MAINE TURNPIKE AUTHORITY

ADDENDUM NO. 1

CONTRACT 2015.06

**INTERCHANGE 36 SACO TOLL PLAZA LANE ADDITION (MM 36.0) & VARIABLE
MESSAGE SIGN RELOCATION (MM 28.3)**

SHEET NUMBER:
24 OF 54

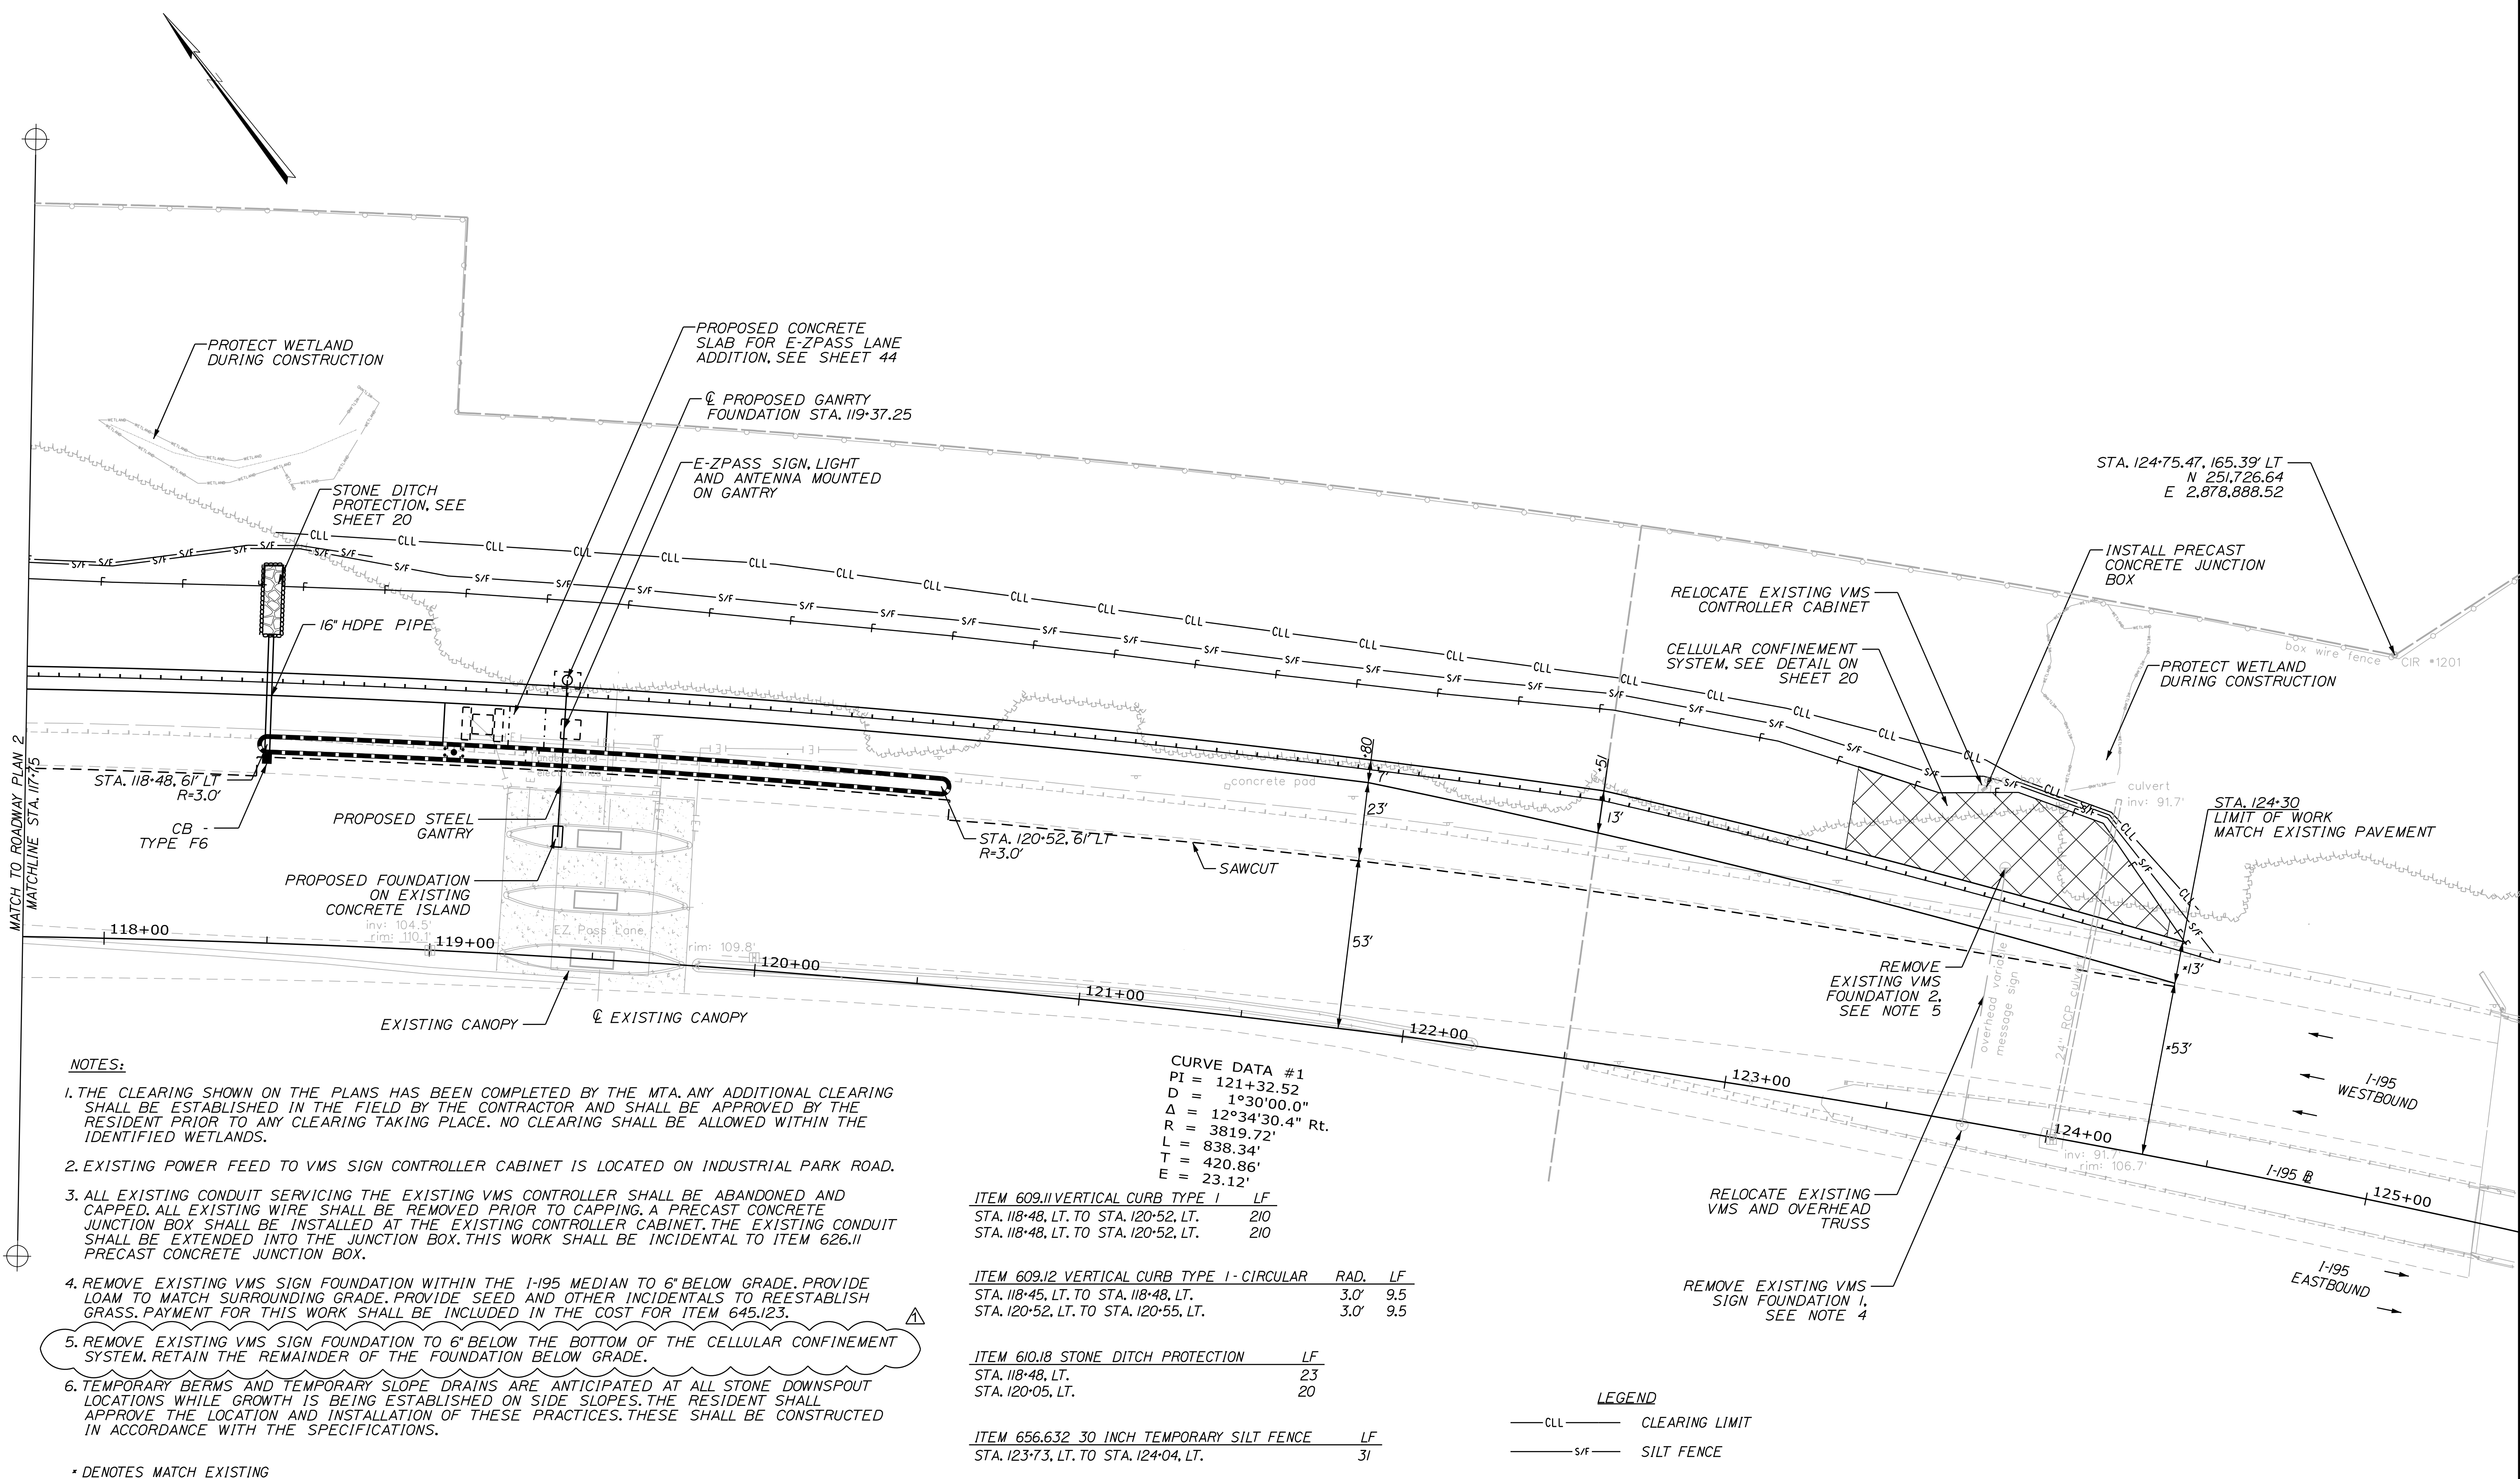
NOTE: AN ESTIMATED QUANTITY OF ITEM 202.203 PAVEMENT BUTT JOINT - 350 SY AND ITEM 403.21 HOT MIX ASPHALT, 9.5 mm - 100 TONS, HAVE BEEN INCLUDED TO ADDRESS THE PAVEMENT SHIM NEEDED ON I-95 WESTBOUND (STATION 109+00 +/- TO STATION 111+50 +/-, LEFT) AT INTERCHANGE 36.
